# FOUNDATION LUTHERAN CHURCH

## GRADING AND EROSION CONTROL CONSTRUCTION DOCUMENTS

SHEET NAME  
GEC COVER

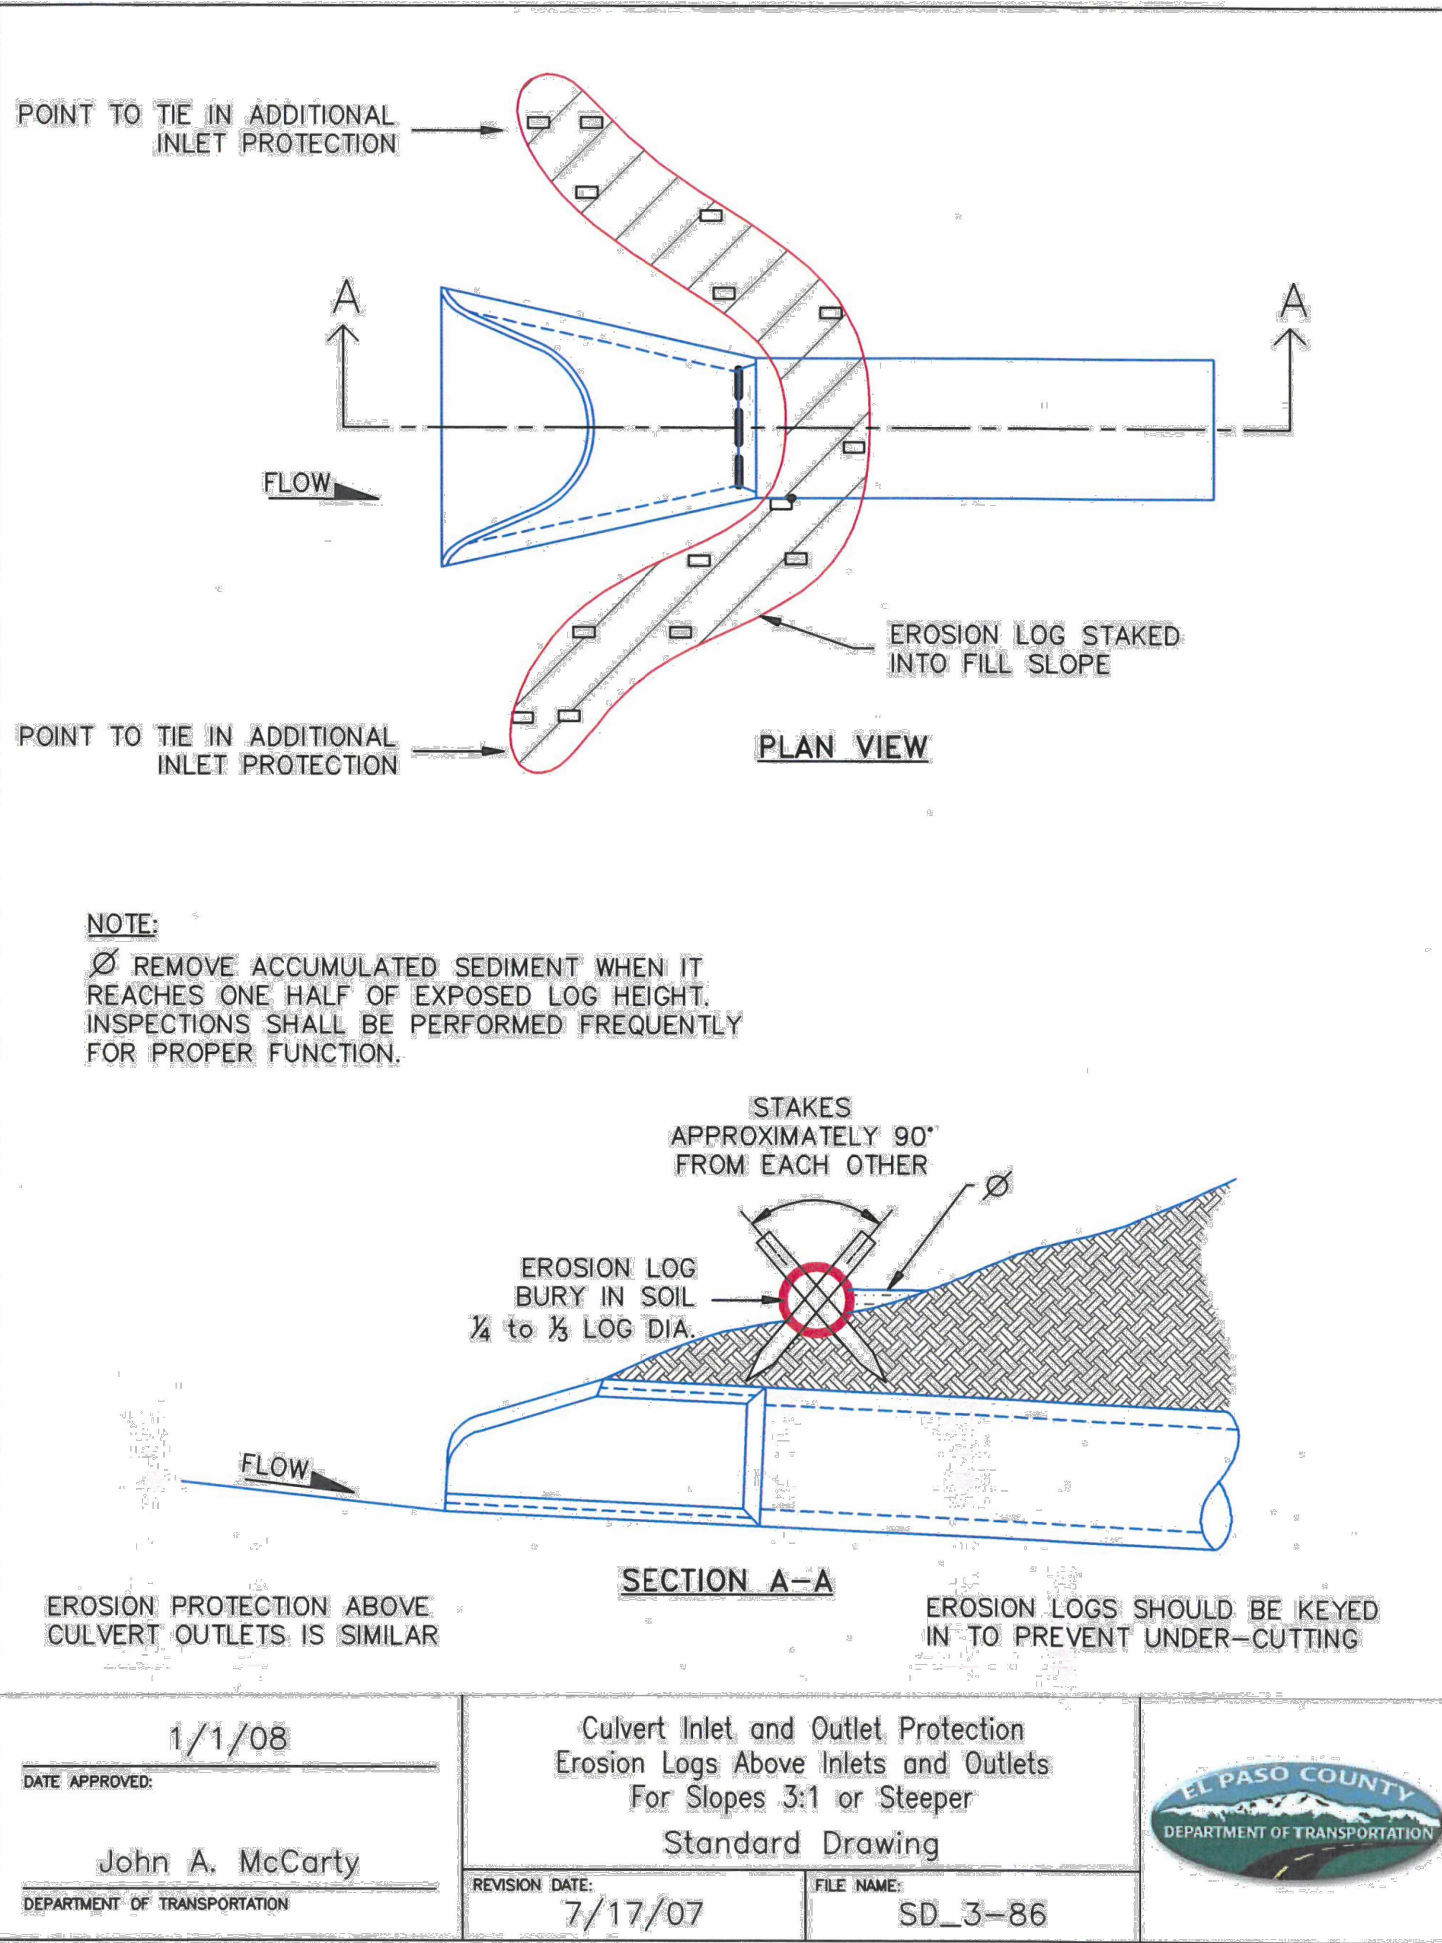
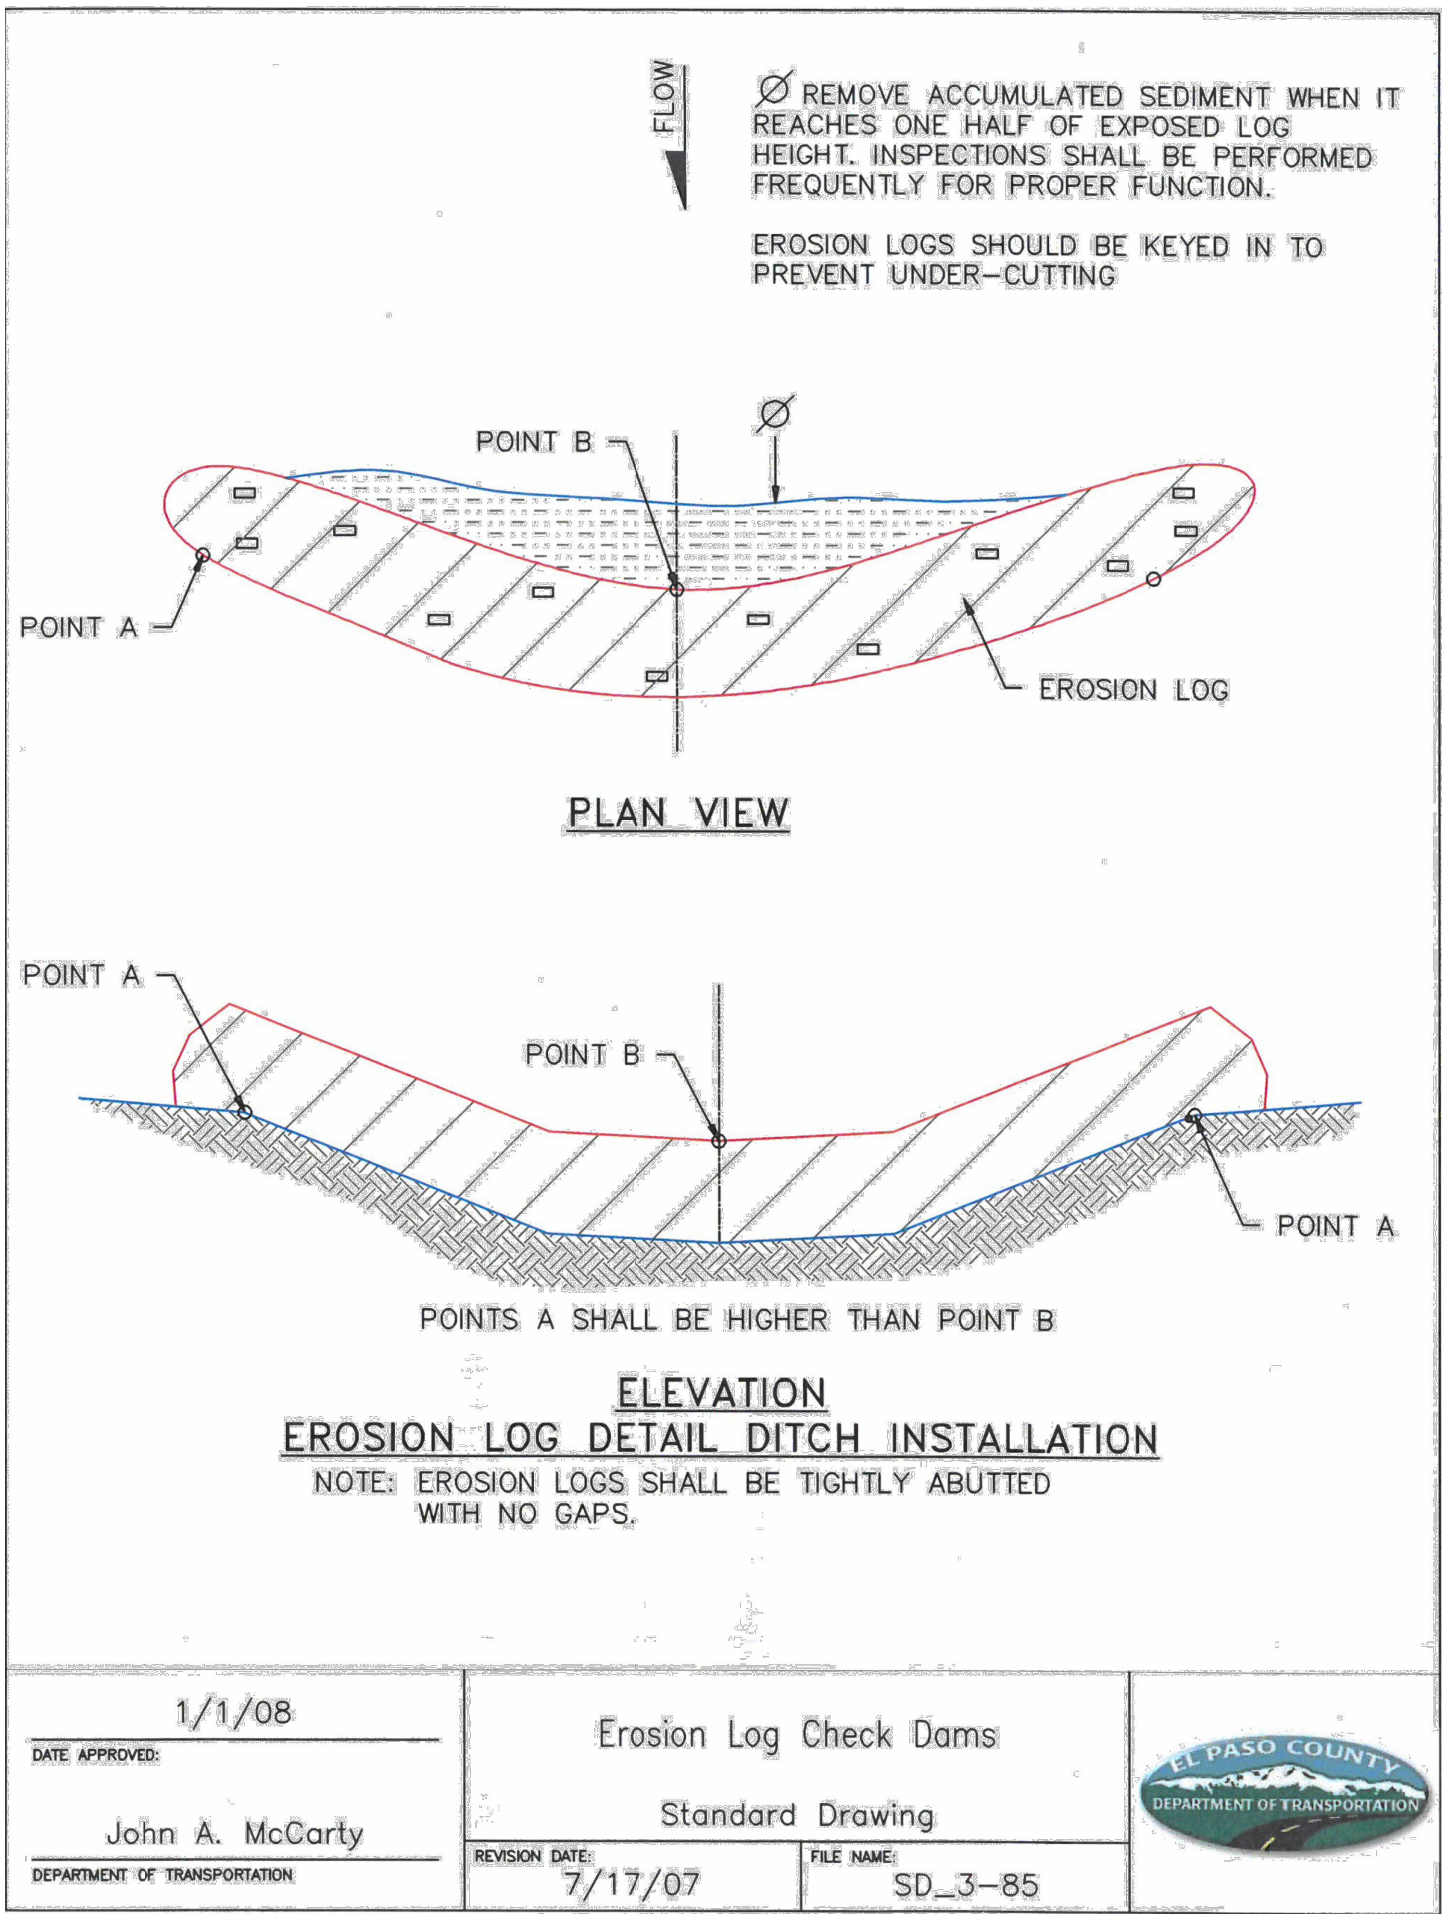
Should this be south?
